Reply to reviewers:

The title of the paper has been modified to "InundatEd-v1.0: A Large-scale Flood Risk Modeling System on a Big-data - Discrete Global Grid System Framework"

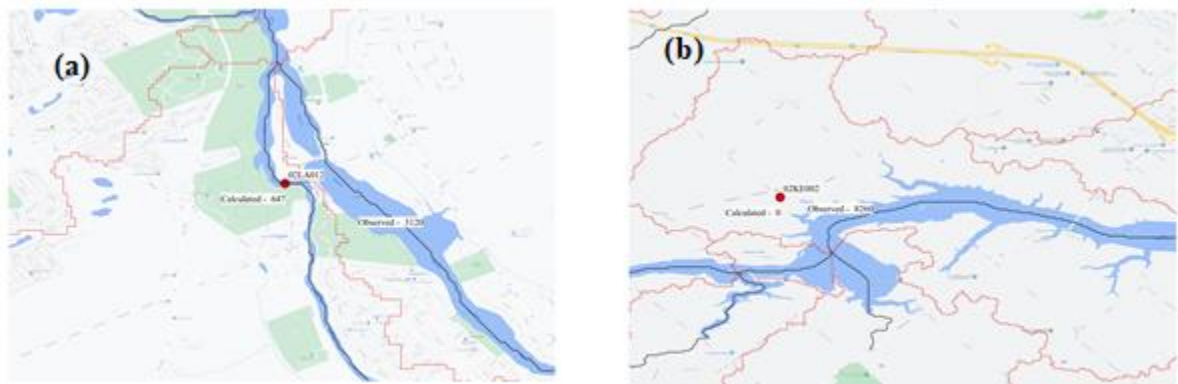
1. The paper presents a simple flood modelling framework model based on HAND to predict flood levels in two watersheds in Ontario and Quebec using a big-data discrete global grid systems-based architecture with a web-GIS platform. The authors indicate that the combination of simple conceptual flood method with big-data approaches remains largely uninvestigated, but they don't make a clear demonstration of what their big-data processing system brings that cannot be accomplished by existing large-scale flood modelling methods at the continental scale.

Our discrete global grid-based flood modeling approach addresses multiple computation- related concerns that often arise in large-scale flood modeling systems. These solutions and developments, listed below, have been incorporated into the manuscript's introduction and highlight the novel aspects of our approach and its application. The relevant text, are copied below:

c) Figure 4b using manual snapping:

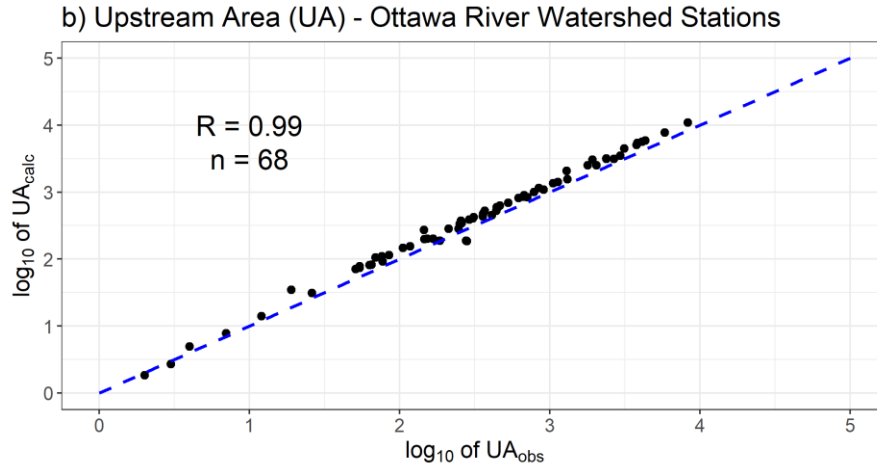
2. There is little mention of uncertainty concerning flood estimates in this study, and some of the discrepancies between theoretical and estimated values (e.g. Figure 7b; Figure 8 for large return periods) are dismissed without enough analysis on the implications on the predicted flood zones. The justification for some methodological steps needs to be improved, for example, the Lotter method, which is used here despite being singled out in the cited reference (Tullis, 2012) as the only approach “not recommended for use”.

The discrepancy in what is now Figure 4b arose primarily from the limited resolution (number of decimal places in lat-long) of the station location information; incorrect reporting of station locations and/or their drainage area (Environment Canada reported the drainage area as 0 for multiple stations); and sometimes wrongly snapping stations to the tributaries rather than to the main river, particularly in cases involving a wide river channel or braided river. For example, station 02LA012 (a, below) intersects one of the drainage tributaries in the model, but actually it is a part of the main river. Station 02KE002 (b, below) is almost a kilometre away from the main river by location. We earlier employed a 300m search radius to search for the nearest river for every station, but in the borderline cases this method failed. However, this does not affect the model itself, as we have used the station-specific drainage areas reported by Environment Canada to create the regional regression model. Section 3.1 has been edited to include this brief discussion. Additionally, we have copied below (c) a version of Figure 4b which resulted from manually selecting the channel for each station. The strong positive correlation (0.99) indicates that the discrepancy was location-related, as opposed to a shortcoming of our network delineation process.
